UNITED STATES PATENT AND TRADEMARK OFFICE

Office Action Summary	Application No. 10/574,425	Applicant(s) LINDH, HANS	
	Examiner PAUL T. CHIN	Art Unit 3652

DETAILED ACTION

Exhibit A

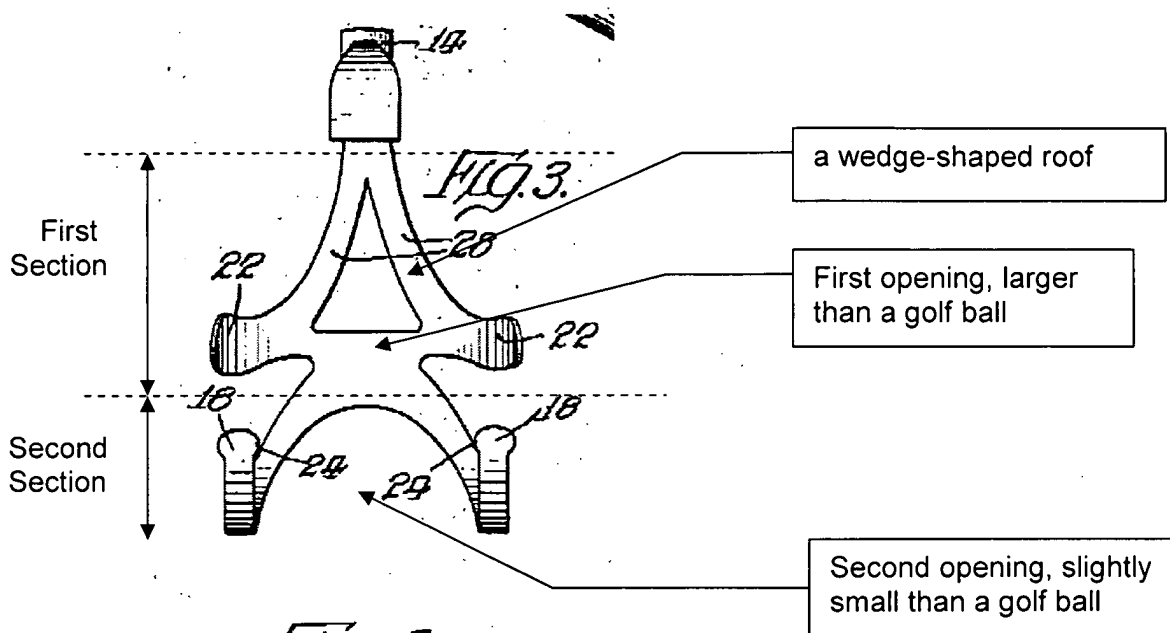
Zimmers (2,738,214) discloses a golf ball retrieval device (see Exhibits A,B) comprising an elongated handle (12,14), a cage having a rear end facing the elongated handle (12) and a front end facing away from the elongated handle (12), and a roof (see Figs. 2,3, and 4) extending from the rear end to the front end, a first section (22,22,28,28) located at the rear end of the cage, a second section (16,16) located at the front end wherein the first cage section has a first opening (see Fig. 3) and the second opening located the opposite of the rear end. Note that the spaced apart outwardly extending fingers (16,16)

and a roof (28) defines a first opening, which has a greater diameter than a golf ball, (see col. 2, lines 19-26) and the extending fingers (16,16) and a roof (28) defines a second opening (Figs. 1,2,3,8, and 10), which has a lesser diameter than a golf ball (see col. 2, lines 13-19). Exhibits A and B teaches a substantially wedge shape roof.

Exhibit B

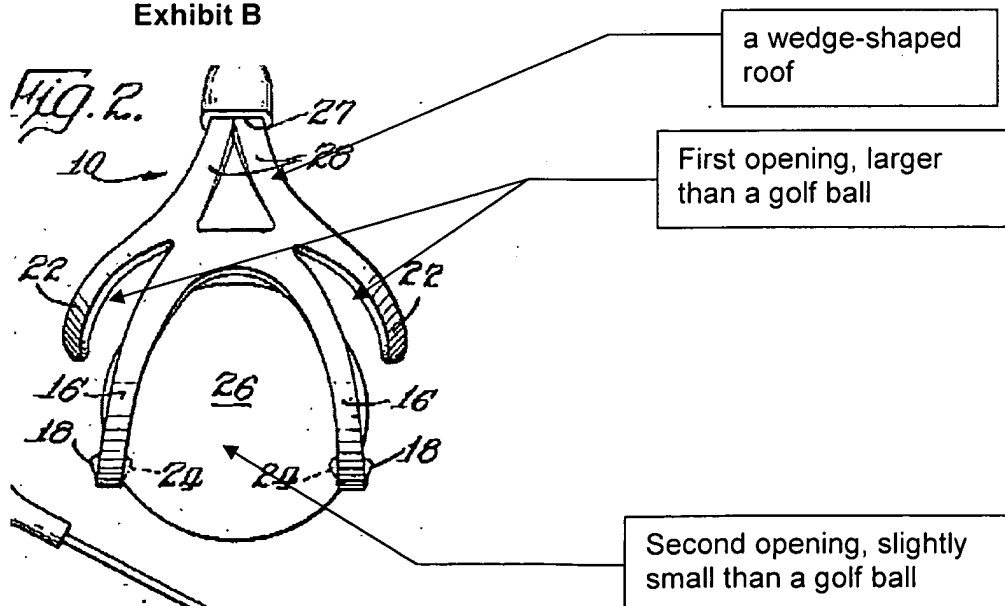
Re claim 3, Exhibit B substantially teaches a plane defined by an edge of the second opening defined an angle with respect to a longitudinal axis of the handle (12).

Exhibit C

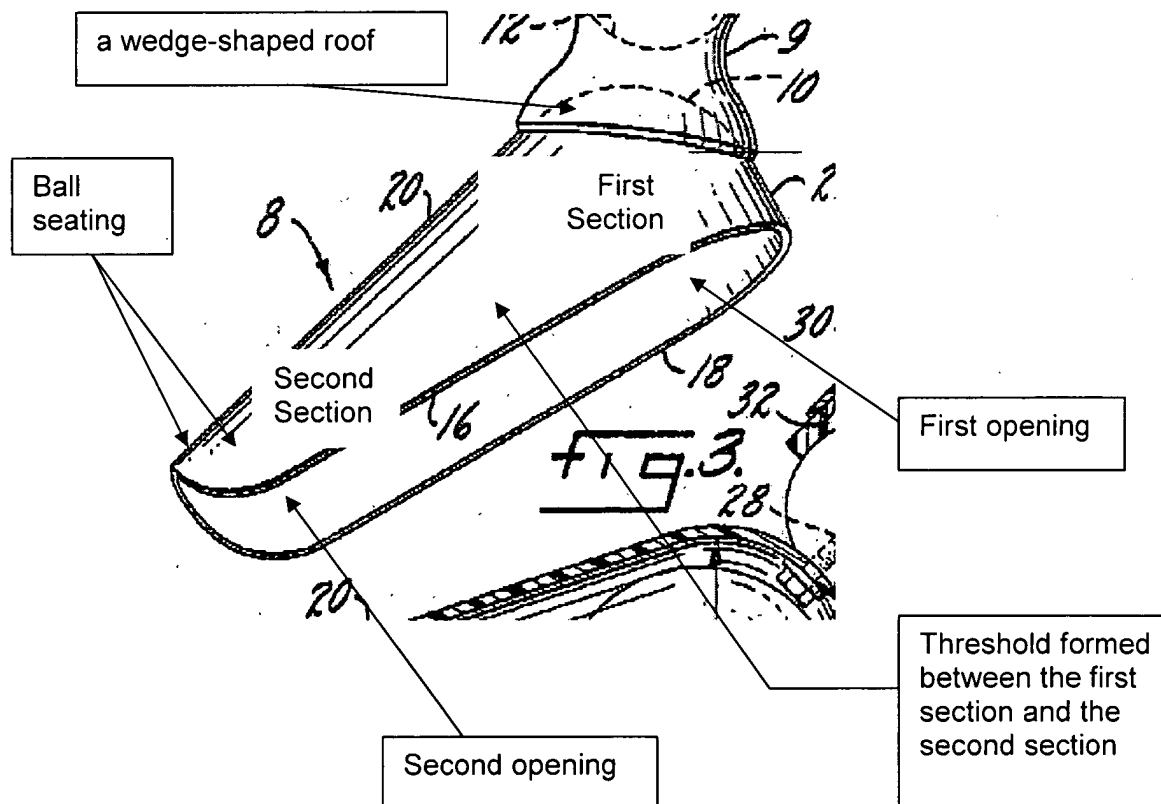
Jenkins (3,265,430) discloses a golf ball retrieval device comprising an elongated handle (13,15), a cage (see Exhibit C) having a rear end facing the elongated handle and a front end facing away from the elongated handle, and a roof (see Figs. 1-3) extending from the rear end to the front end, a first section (see Exhibit C) located at the rear end of the cage, a second section located at the front end wherein the first cage section has a first opening (see Exhibit C) and the second opening located the opposite of the rear end. Note that the spaced apart outwardly extending walls (16,18) and a roof (20) defines a

first opening, and the frontal extending walls (16,18) and a roof (20) defines a second opening as shown below. Jenkins's golf ball retrieval device (3,265,430) does not clearly teach the dimensional structure of the first and second openings to capture a golf ball. However, Jenkins's golf ball retrieval device (3,265,430) teaches that the upper portion of the opposed walls of the first opening is substantially smaller than the golf ball (col. 2, lines 3-8, and Fig. 3) and figures 4 and 5 also teach that the opposed and spaced apart walls (38,40) has a distance being smaller than a golf ball (col. 2, lines 22-47).

Re claim 2, Exhibit C shows a threshold formed between the first section and the second section to prevent the ball from rolling from the ball seating.

Re claims 3 and 5, Exhibit C teaches a plane defined by an edge of the second opening defined an angle with respect to the longitudinal axis of the handle.

Re claim 4, the ball seating (See Exhibit C) and the cage roof (20) are capable being positioned a center of gravity of the ball beneath the longitudinal axis of the elongated handle (15) because the distal end of the handle, a ball or sphere, is designed to be freely rotatable at a socket joint (12).
